**Brighton  
Council**

**ATTACHMENT A**  
**AGENDA ITEM 6.1**

St Ann's  
Lifestyle Village  
99-88, 28 Stanfield Drive,  
Old Beach Tas 7017

## REQUEST FOR FURTHTER INFORMATION RESPONSE

## CONCEPT ROUNDAABOUT DESIGN

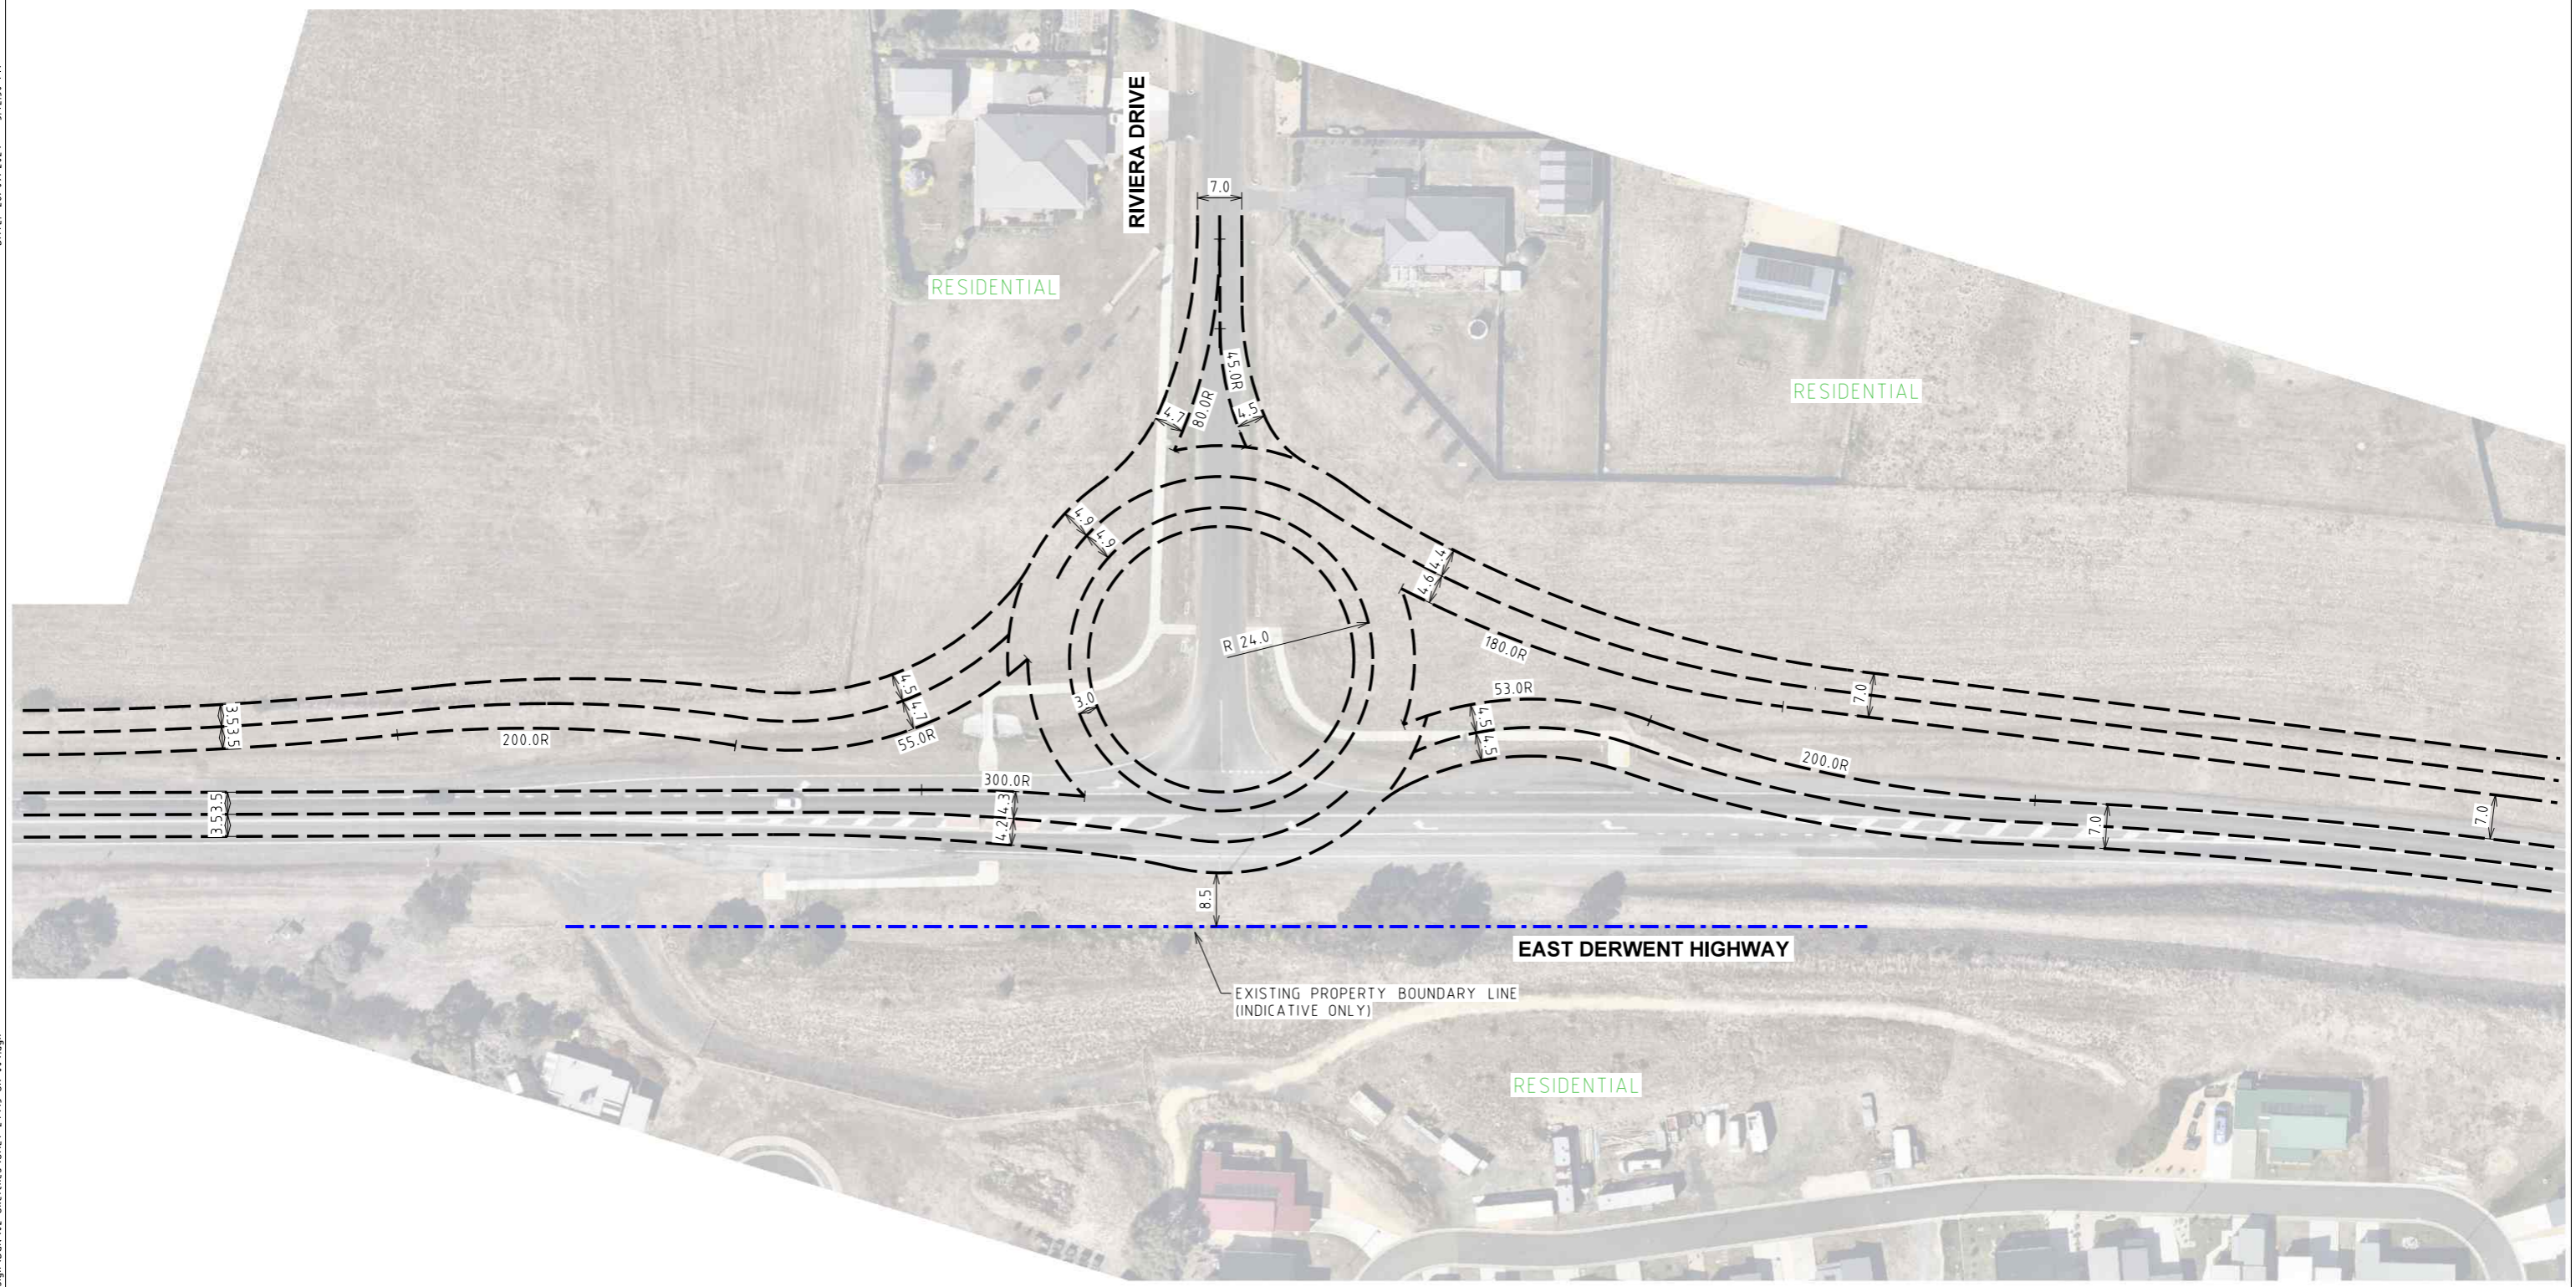
*7. provide an indicative roundabout design at the Riviera Drive/East Derwent Highway (EDH) intersection based on the EDH being single and double lane and demonstrate the impact on the proposed development with and without a connection to Stangfield Drive connection.*

*Advice: the indicative design can be at a concept level but must provide sufficient information to determine the impact on the proposed development.*
